CASTLEGAR & DISTRICT COMMUNITY COMPLEX RTU REPLACEMENT PRJ24039

ADDENDUM NO. 2

Issued: April 17, 2025

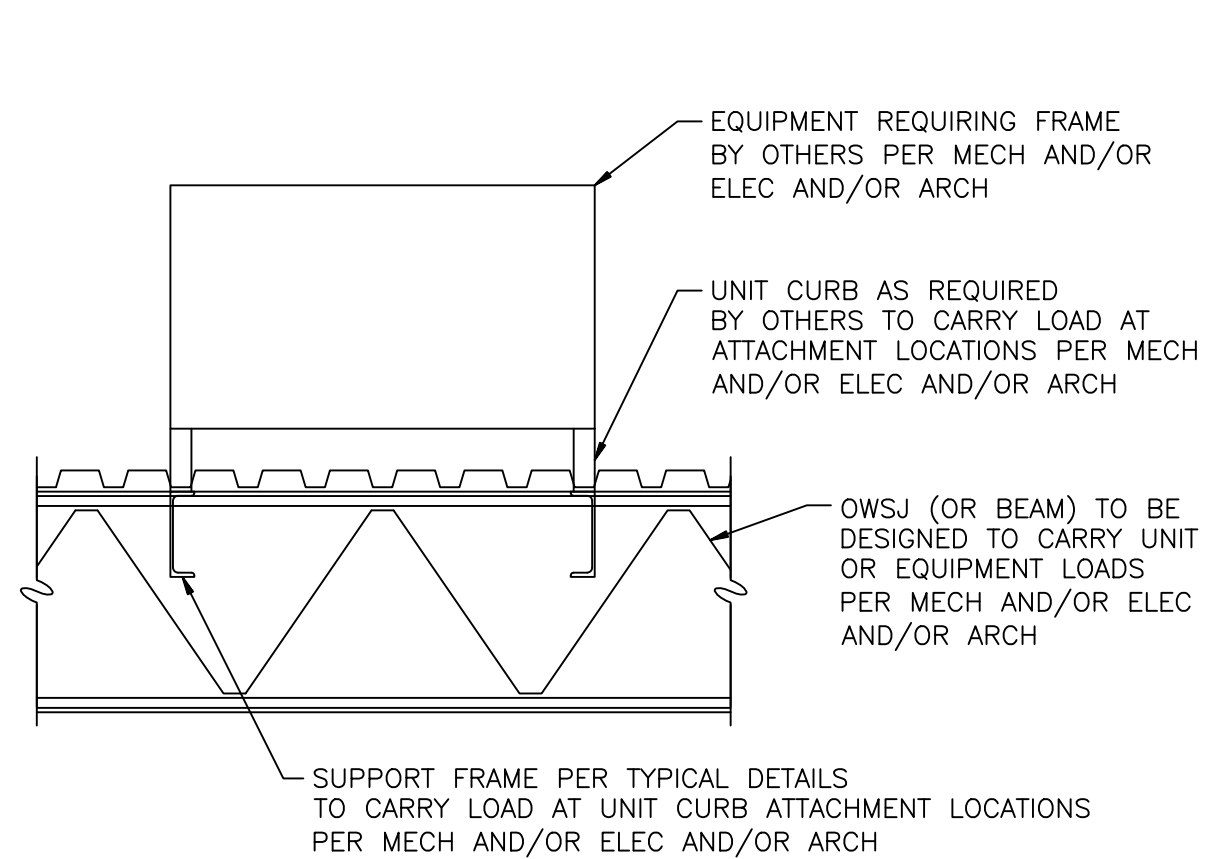
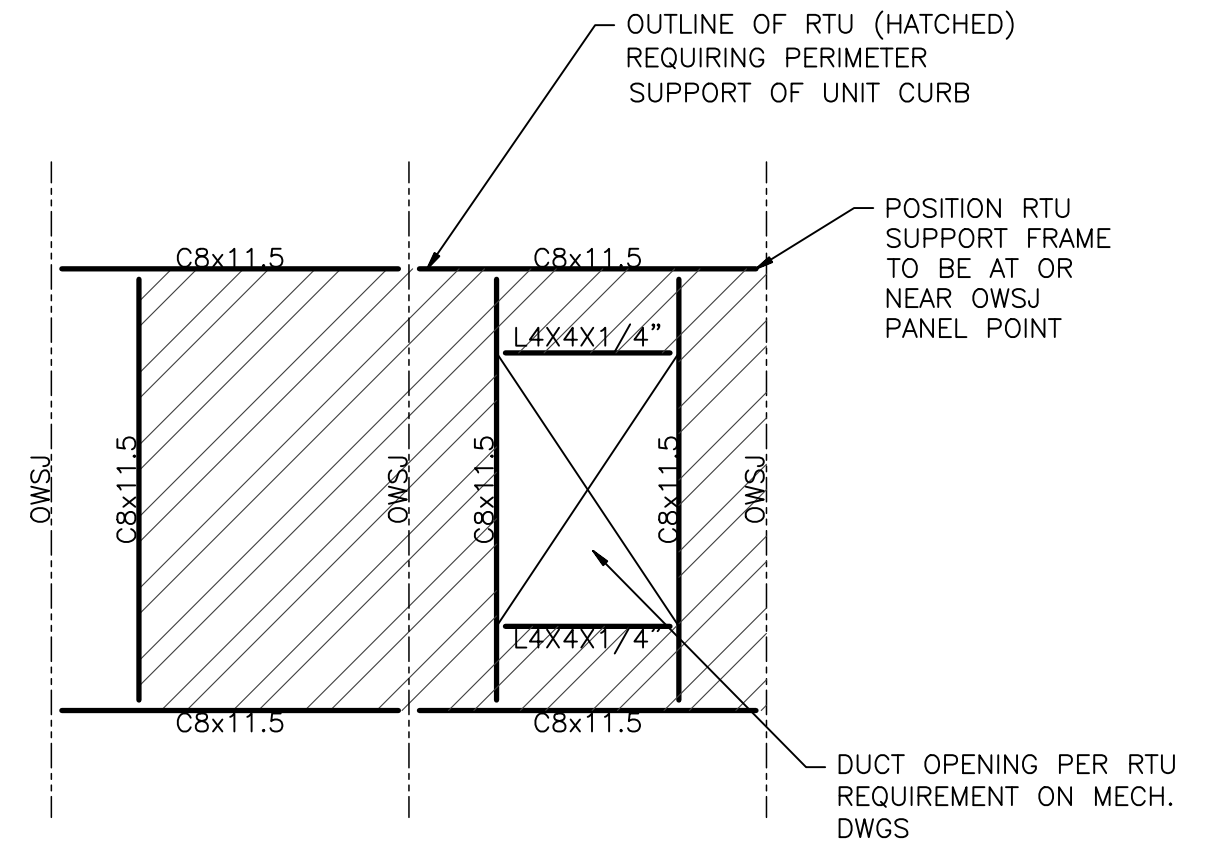
C1: See attached SK1, SK2, SK3, SK4 & SK5 structural drawings provided by CWMM Consulting Engineers Ltd. for new curb detail to be completed for the RTU-3 pool change rooms (FS-3).

"RTU" REFERENCES ARE TO RTU-3 (TRANE MODEL DHK060A3SAH WITH 1081 lb OPERATING WEIGHT OF 4.44' WIDTH AND 7.34' LENGTH) ON MECH. DWGS REPLACING EXISTING FS-3 UNIT (ICE WESTERN HTDM 82 SERIES MODEL 400 SEEMING TO INCLUDE MIXBOX AND HIGH EFFICIENCY FILTER PLENUM OF 3609 lb WITH HIGH EFFICIENCY FILTER SECTION DOWN DISCHARGE COMPONENT OF 636 lb AND 60" MAIN WIDTH AND 171" LENGTH).

SIZE OF OPENING AND LOCATIONS OF SUPPORTS TO BE CONFIRMED BY TRADE PRIOR TO FABRICATION. CONFIRM ALL LOCATIONS WITH ARCH., MECH. DWGS.

1. FASTEN DECK TO NEW FRAMING WITH HILTI POWDER ACTUATED FASTENING SYSTEM OF X-ENP PINS @ 6" O/C. OR EQUAL

DESIGNED: A.J.M.	DRAWN: N.M.
DATE: 2024-12-16	
SCALE: 3"=1'-0"	SHEET NO. A2.03
APPROVED BY: DAVID FOOKES

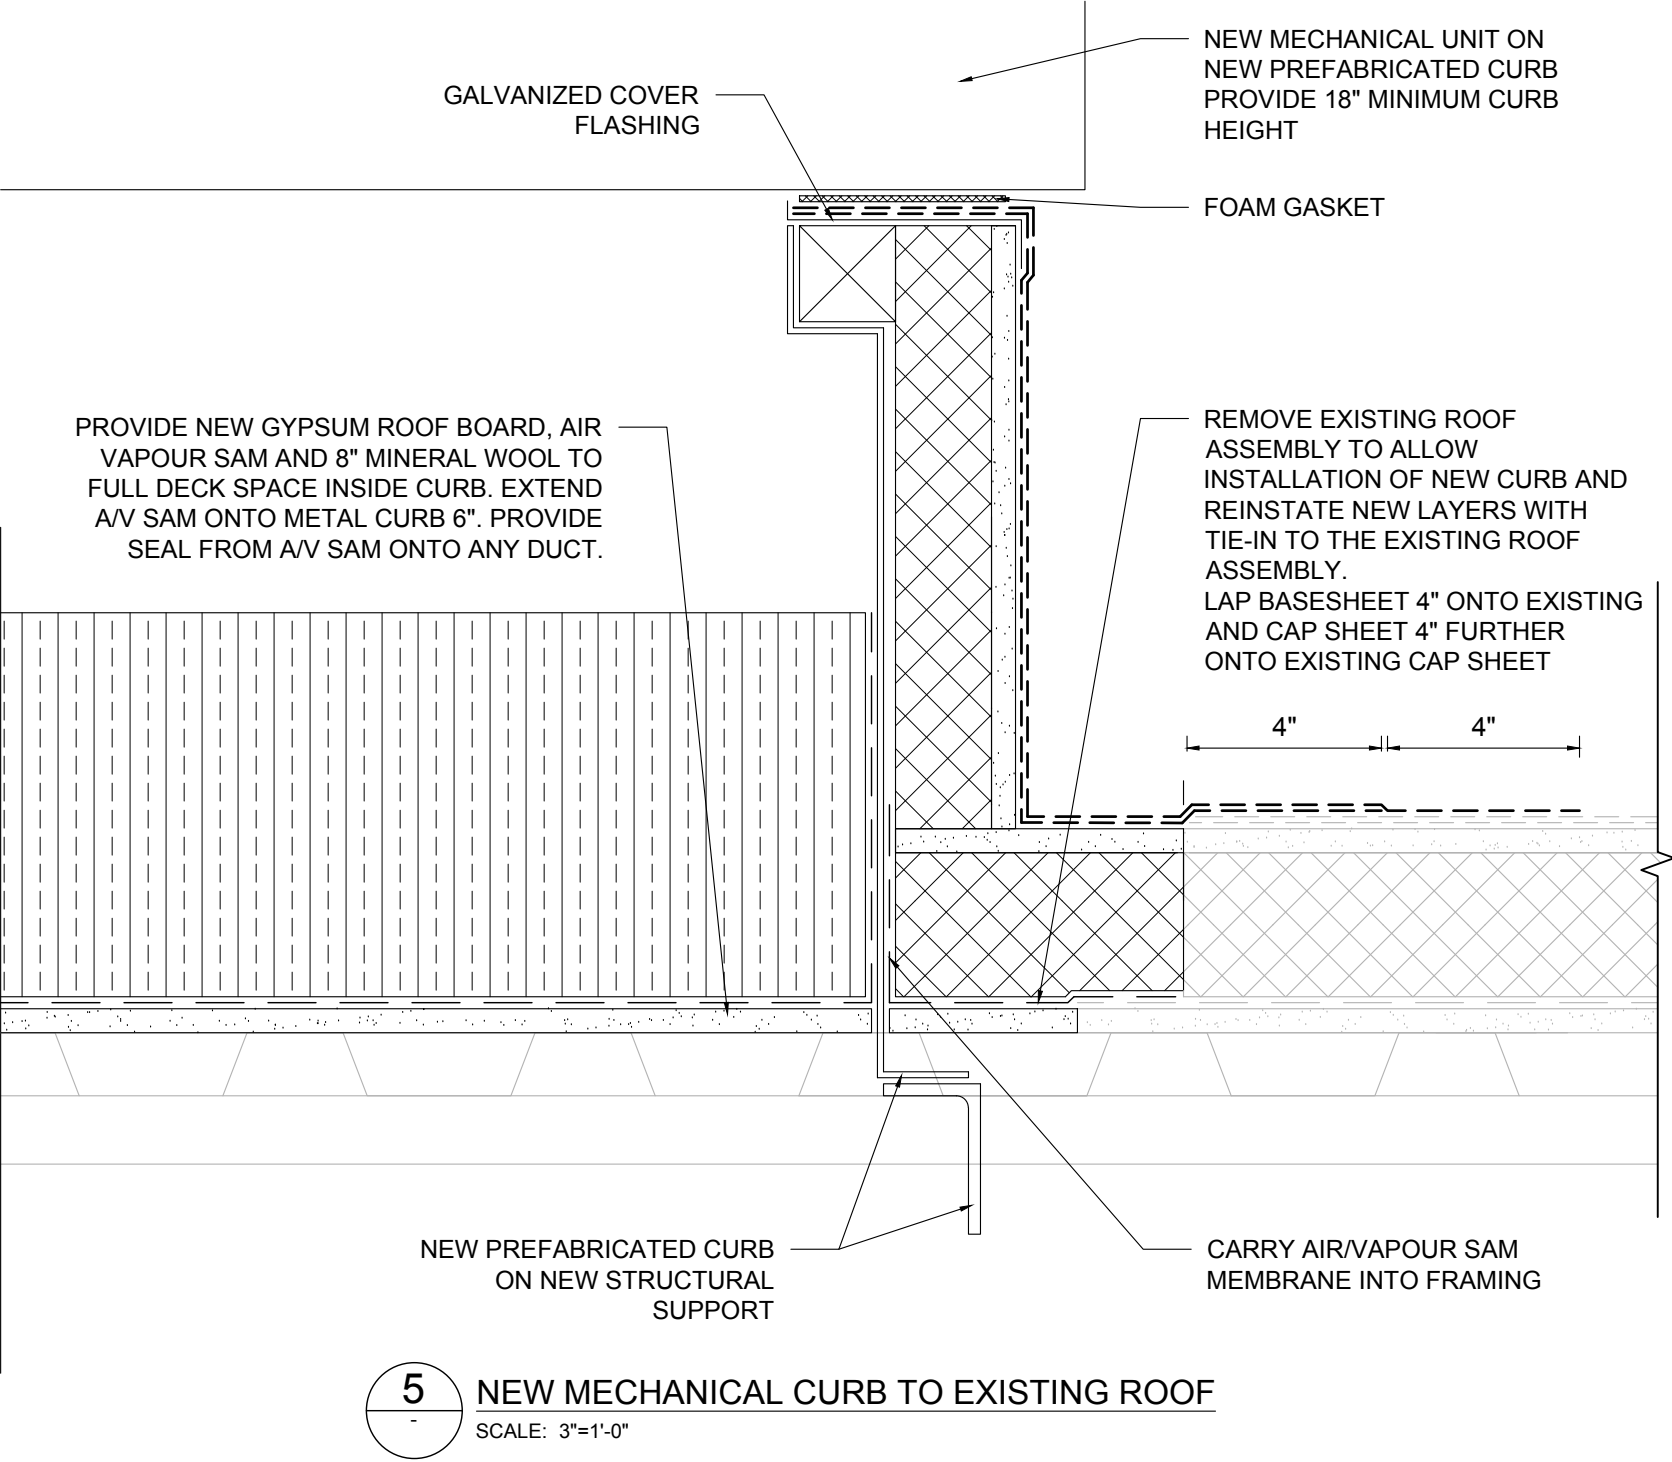
C2: See attached A2.03 detail provided by Evoke Buildings for roofing tie-in and roofing details associated with the new RTU-3 curb.

NEW MECHANICAL CURB
TO EXISTING ROOF
